**Proposed Flat with Permitted Shop and Services, Eating Place,
Social Welfare Facility and Public Vehicle Park (excluding container vehicle) at
(i) Government Land at Junction of Tai Chung Kiu Road and On Sum Street (new Lot to be known
as Sha Tin Town Lot 626 (STTL 626))**

**(ii) Government Land at Junction of On Sum Street and On Ping Street (new Lot to be known as
Sha Tin Town Lot 627 (STTL 627))**

(Application No. A/ST/1053 under s.16 of the Town Planning Ordinance)

Responses to Comments – Departmental Comments

Title
PHOTOMONTAGE - VIEWPOINT 1

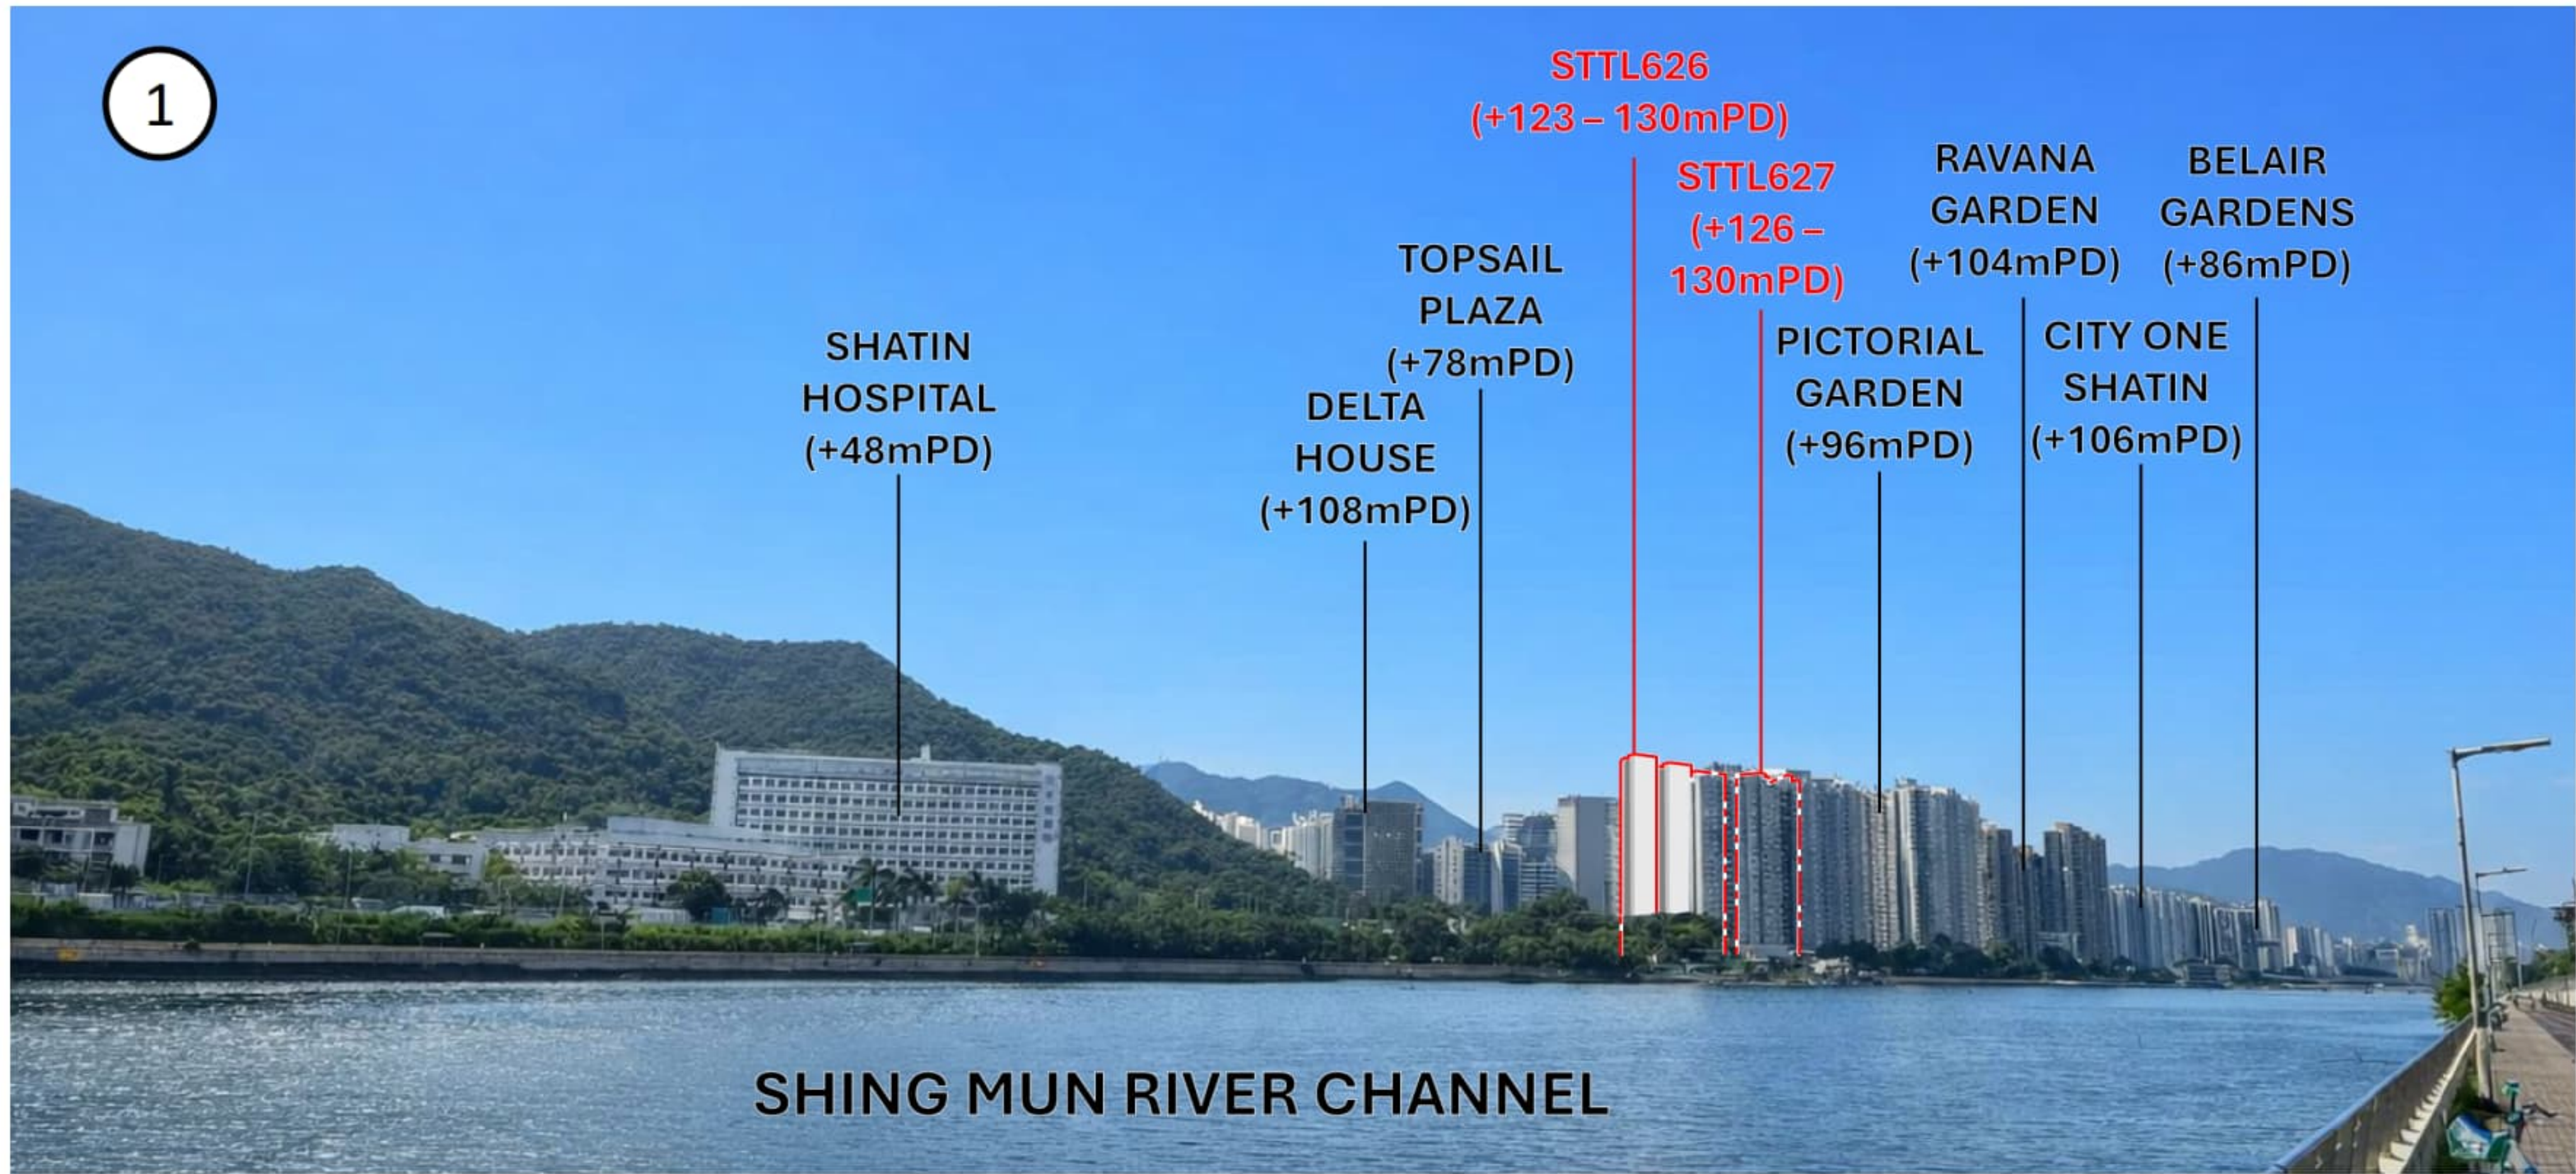
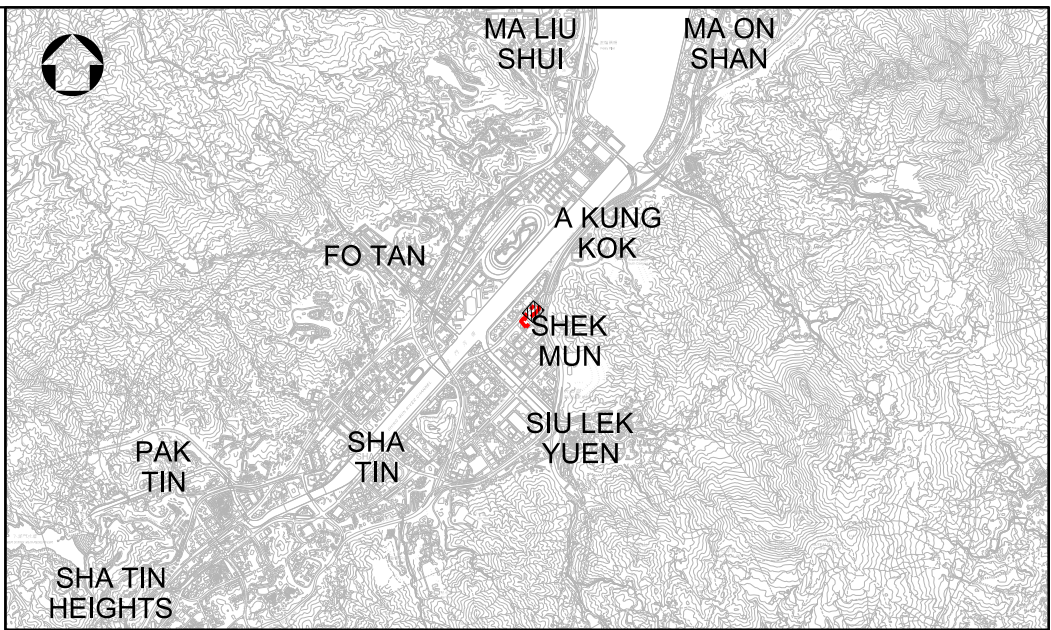
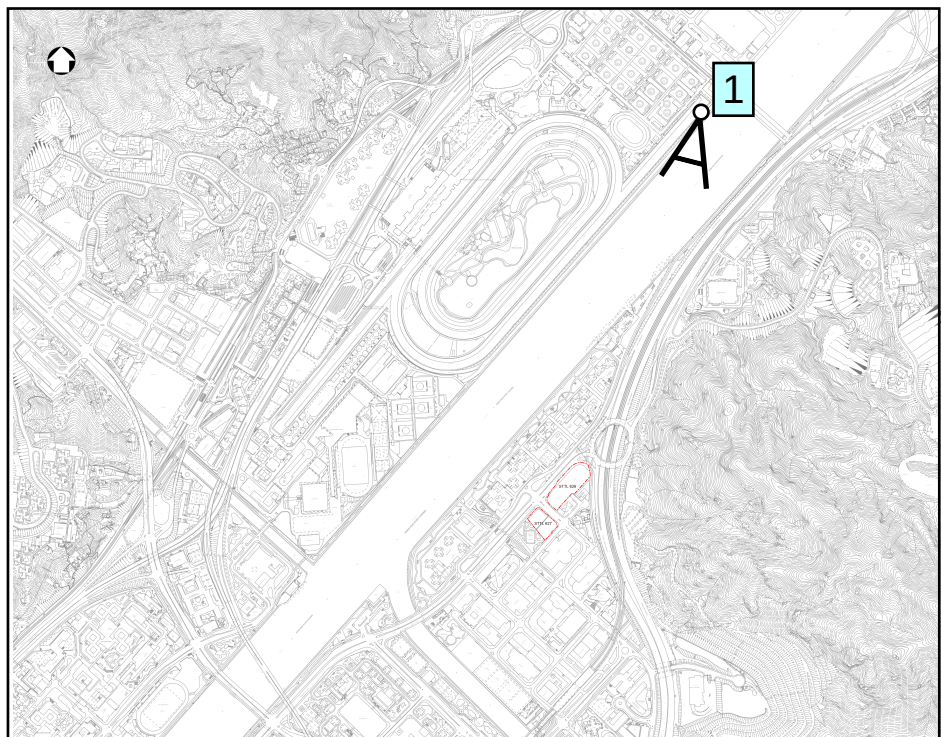
(i) VP1 – the location of the proposed developments appears to be shifted to the right-hand side of the photomontage and half of the building façade appears to be screened by Pictorial Garden; and	Noted. The photomontage is updated in Fig. no. MMH/CE19/TO4/PR/FIG/5.2 of A_ST_1053_FI(1)_Plans_and_Drawings .
	(ii) VP2 – the location of the proposed developments appears to be shifted to the right-hand side of the photomontage and STTL627 appears to be screened by Ravana Garden.	Noted. The photomontage is updated in Fig. no. MMH/CE19/TO4/PR/FIG/5.3 of A_ST_1053_FI(1)_Plans_and_Drawings .
4	Comments from Environmental Protection Department, dated 25 August 2026

GROUND FLOOR PLAN
(STTL 626)

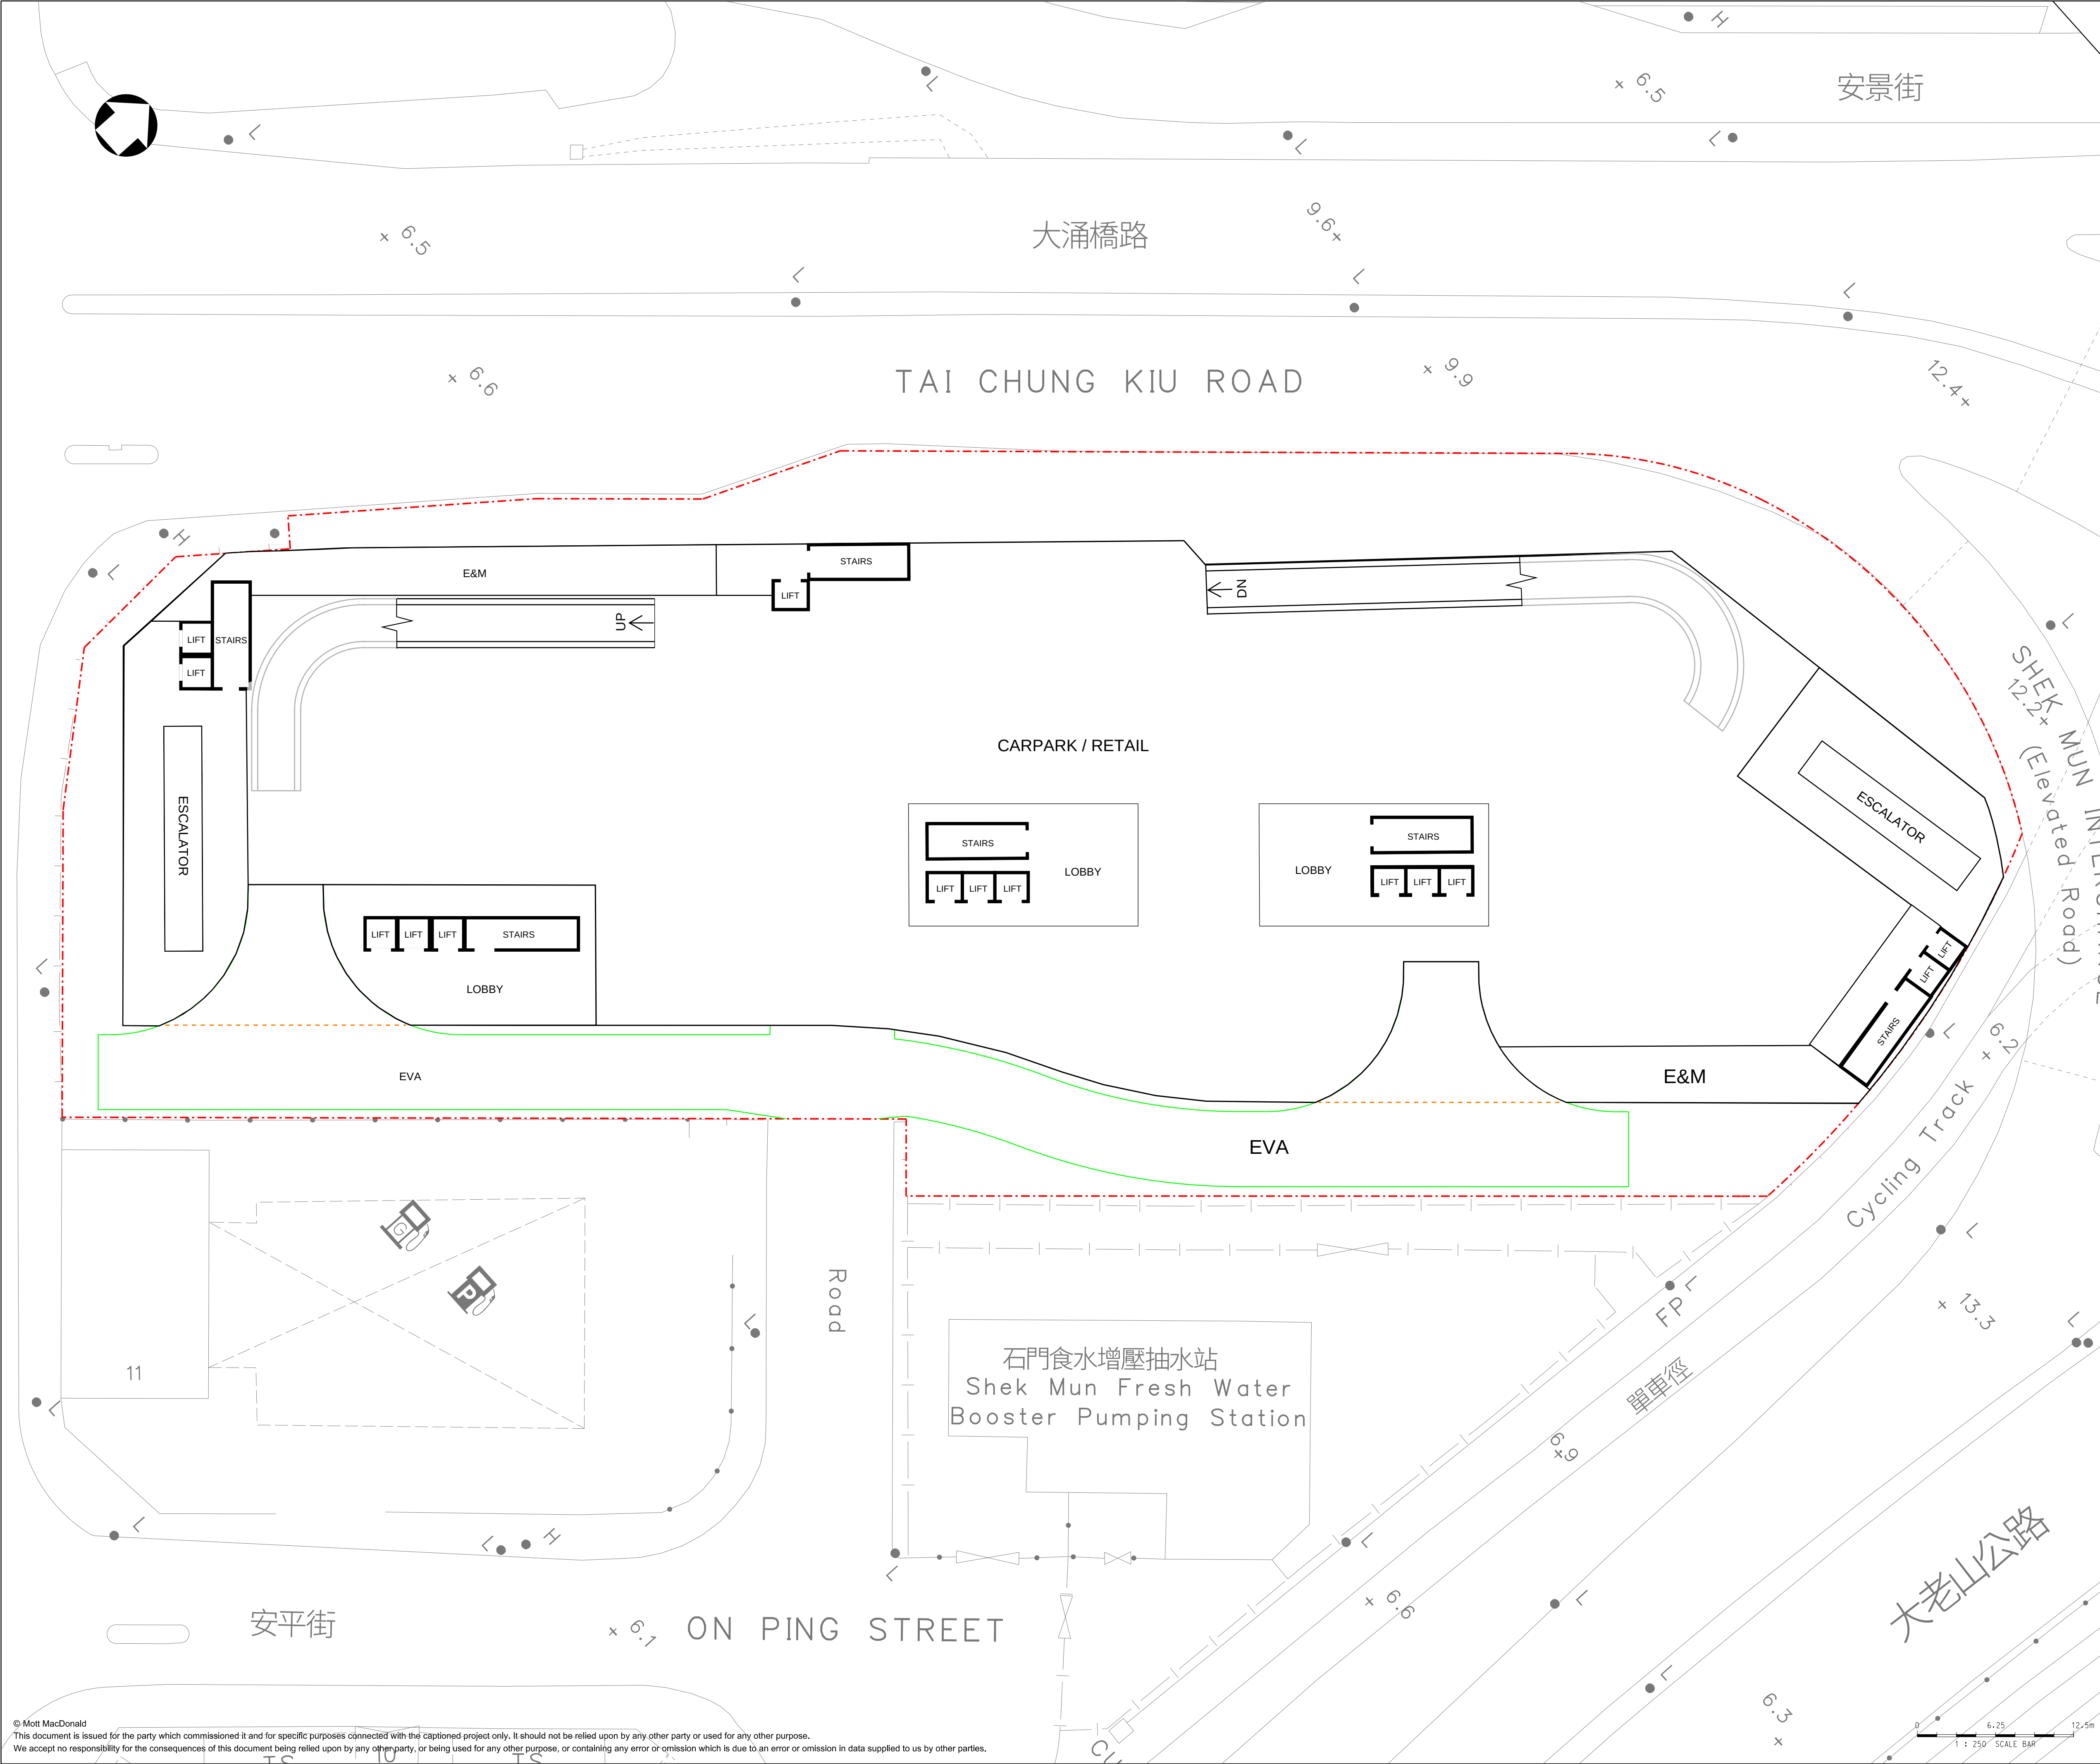
3. While we understand that the architectural drawings may only be the preliminary framework and may be subject to further changes in the future, please ensure that all the building structures on G/F, 1/F and 2/F (mainly car parks and retail uses) are at least 3m away from the high pressure town gas pipeline, as this is the typical setback distance required by Towngas for maintenance as well as a safety requirement under international standards. For residential blocks, the setback distance from the high pressure town gas pipe should be at least 12m.	Noted.
	<u>LPG Safety</u>
